Division of Reclamation,
Mining and Safety

**Re: Project, Permit No. M-1980-244;
Technical Revision (TR-100) Addendum Preliminary Adequacy Review**

VLF2 Liner Inspection

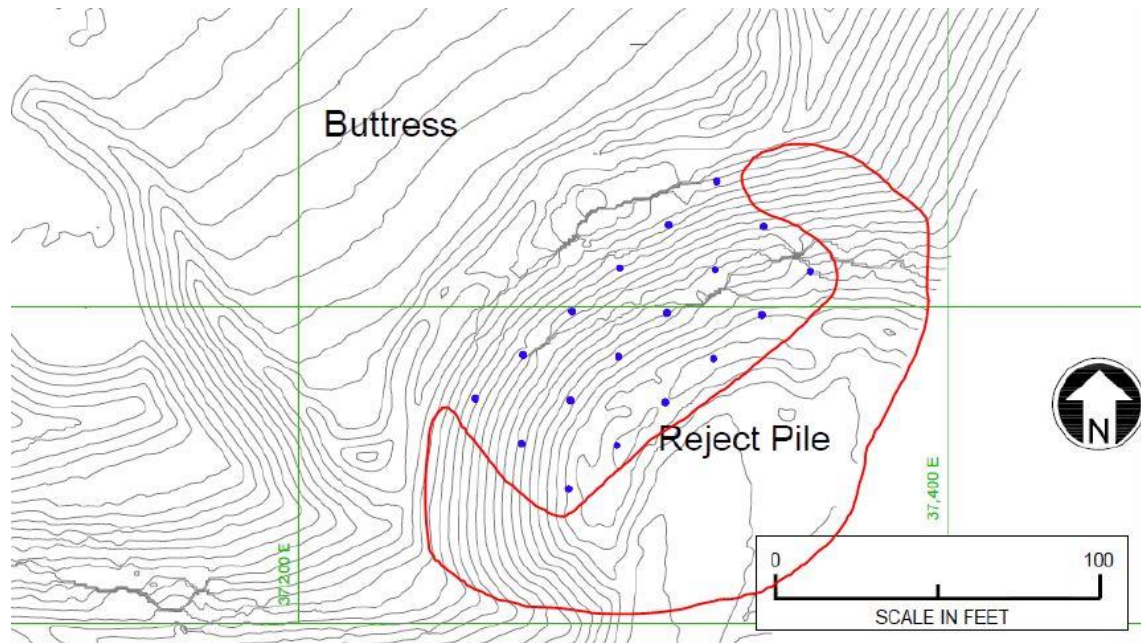
The Division has only one comment of the proposed investigation plan: the proposed pothole investigation plan grid appears to avoid the top (crest) and the flanks of the Reject Pile (please see the red outline in the image included below). The Division is concerned about potential rotational movement that may have been initiated as equipment was beginning to push down the reject material, but may have been subsequently covered up while pushing additional reject material down slope. Please expand the pot-holing investigation to include the crest and flanks (northeast and west sides) of the Reject Pile.
